Access Compliance Report

Public Rights-of-Way

Intersection ID: 49124	Main Street: CLARKE_CREEK_PY	Cross Street: LEGOLAS_LN	Location: SE
ADA ID: E0F463978B12	Ramp Type: PerpDiag	Initial Pass/Fail: Fail	Overall Compliance: No
Severity Score: 8.75			
Codes/Mitigation Info/Possible Solution		Field Measurements/Component Compliance

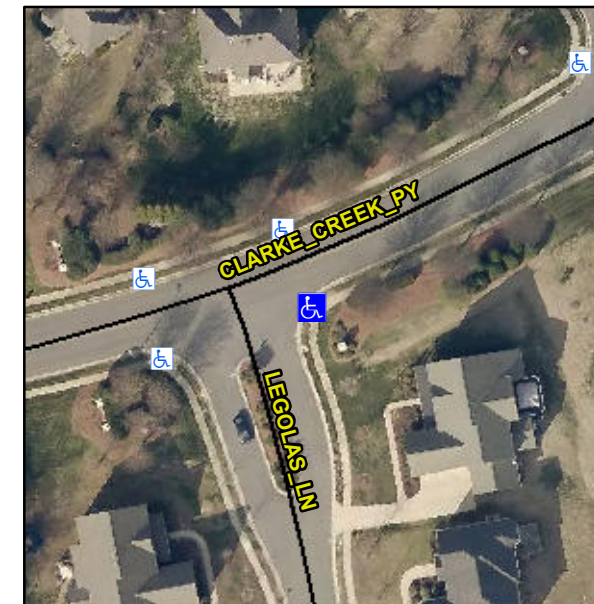
Compliance	Description	Data	Compliance	Description	Data
N/A	Ramp Length (in)	48.0	Yes	Ramp Slope (%)	5.4
No	Ramp Width (in)	46.0	Yes	Ramp XSlope (%)	1.2
N/A	Flare Type LT	N/A	N/A	Flare Type RT	N/A
N/A	Flare Slope LT (%)	N/A	N/A	Flare Slope RT (%)	N/A
N/A	Flare Traversable LT?	N/A	N/A	Flare Traversable RT?	N/A
N/A	Landing Length (in)	N/A	N/A	DWS Provided?	N/A
N/A	Landing Width (in)	N/A	N/A	DWS Contrast?	N/A
N/A	Landing Slope (%)	N/A	N/A	DWS Length (in)	N/A
N/A	Landing X Slope (%)	N/A	N/A	DWS Full Width?	N/A
N/A	Landing Curb? (Y/N)	N/A	N/A	DWS Offset (in)	N/A
N/A	Shared Landing?	N/A			
N/A	Gutter Ponding?	N/A	N/A	Gutter Slope (%)	N/A
N/A	Gutter Lip Ht (in)	N/A	N/A	Gutter X Slope (%)	N/A
N/A	Painted X Walk1?	No	N/A	Painted X Walk2?	No
	X Walk 1 Direction	To N		X Walk 2 Direction	To W
N/A	X Walk 1 Width (in)	N/A	N/A	X Walk 2 Width (in)	N/A
	X Walk 1 Slope (%)	3.0		X Walk 2 Slope (%)	2.0
	X Walk 1 X Slope (%)	2.6		X Walk 2 X Slope (%)	2.6

Remove & Replace Curb Ramp With Two New Directional Ramps or Equivalent.
